Please accept this updated WR V2.0 Summary for NGC's WR regarding the East Pye Project.
This updated summary replaces the WR Summary uploaded as part of Submission S4A7CCF08.
Many thanks.

East Pye Solar Farm EN0110014

**Written Representation Appendices on behalf of
Norfolk Gliding Club**

Figure 2: Map 2 - After East Pye

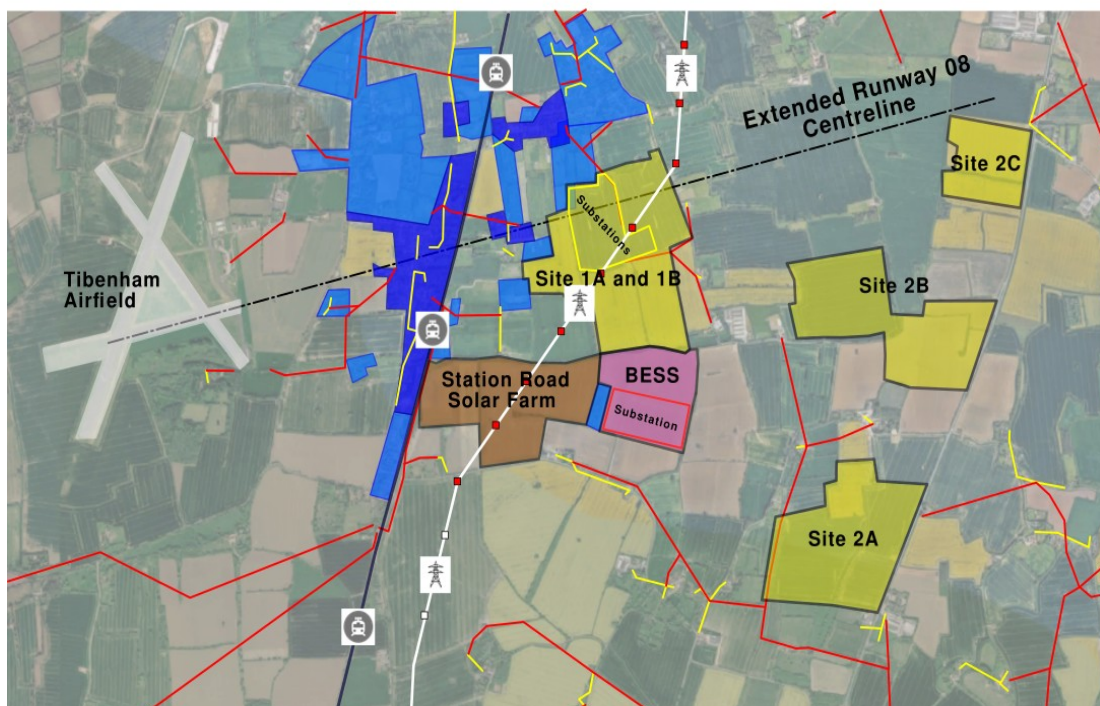
Map 2- shows the situation should the Applicant's proposals go ahead and shows how they would significantly reduce the number of fields available for a forced off-airfield landing such that there would be very few EFATO landout options remaining.
